MAINTENANCE BULLETIN

COMMON SHELTER		FILE NO. 132-A	REVISION:
SUBJECT: DUAL CHANNEL CONTROL CARD OPERATIONAL PROBLEMS		DATE: 3/14/90	CATEGORY: A
		SYSTEMS AFFECTED: ALL

FIGURE 1

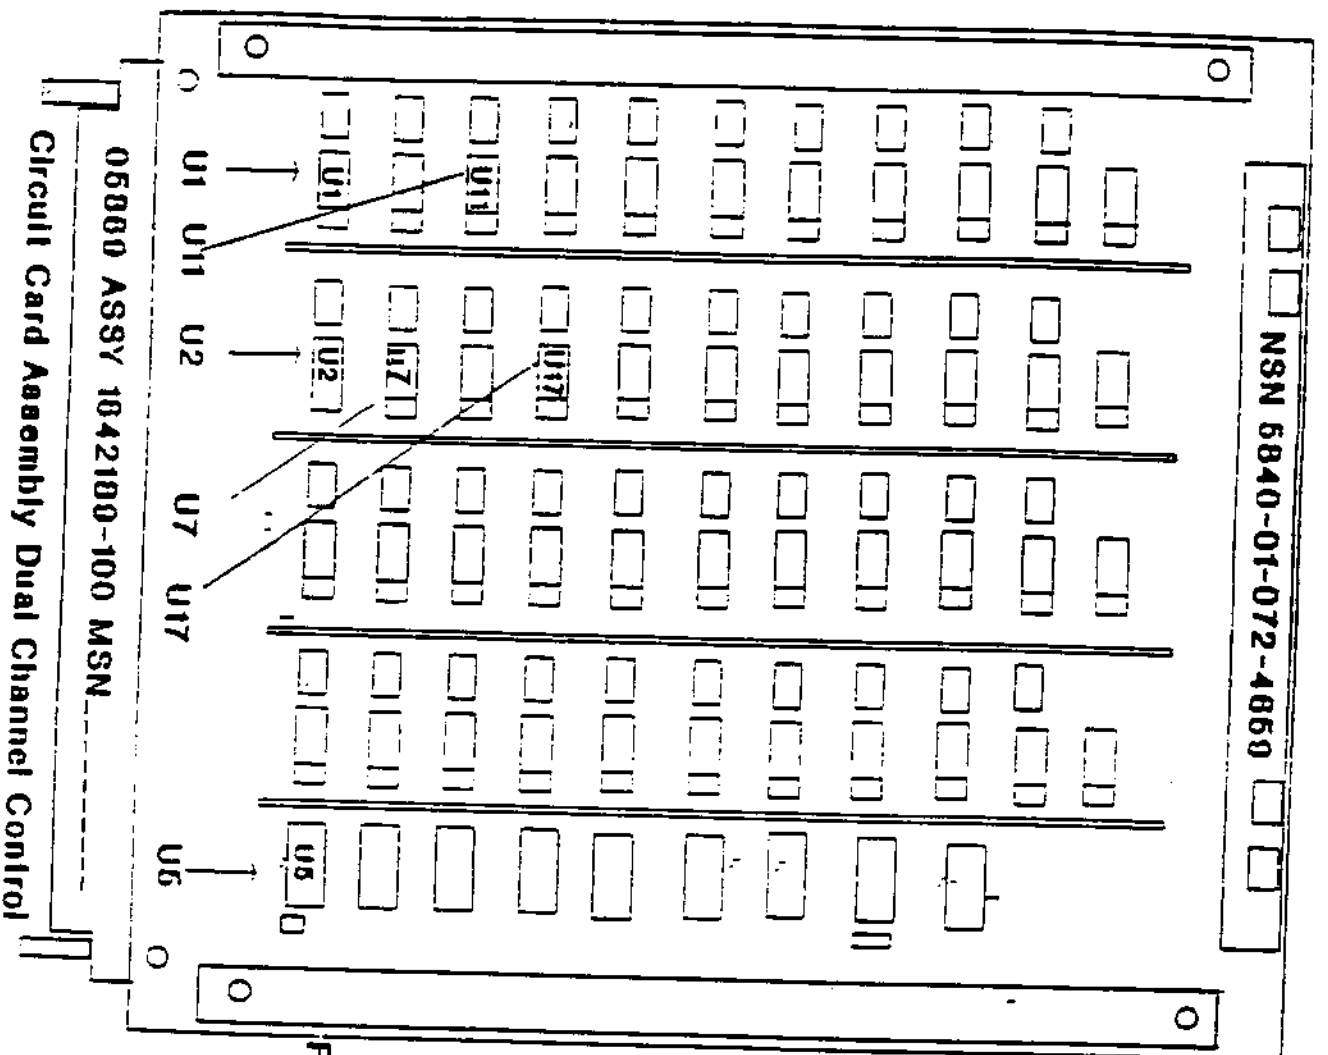
2. PROBLEM: Intermittent malfunctions have been detected when the Common Shelter was submitted to testing at both ambient and extreme temperatures in the Environmental Chamber. These problems were traced to microcircuit 54LS257 on the Dual Channel Control Card (Part Number 1642189-100). Further analysis disclosed that two versions of this microcircuit have been furnished by the manufacturers under the same part number. Earlier versions are characterized as "slow" components, while later versions are "fast" components. When a "fast" component is used in the Dual Channel Control Card, changes are required in the Signal Processor backplane wiring.

a. A new part number (1708261-100) has been established for the Dual Channel Control Card to identify those cards containing the newer "fast" version of the microcircuit. (See enclosed figure 1 for location of microcircuits U1, U2, U5, U7, U11, and U17 on the Dual Channel Control Card.)

b. A new Signal Processor Rack part number (1635898-101) has been established for the new backplane configuration to identify the ones which contain the wiring modifications compatible with the new CCA (1708261-100). This new Signal Processor is compatible with existing 1642189-100 cards and the new 1708261-100 cards.

c. Signal Processor without the backplane wire changes (part number 1635898-100) must use the 1642189-100 CCAs with the "slow" microcircuit.
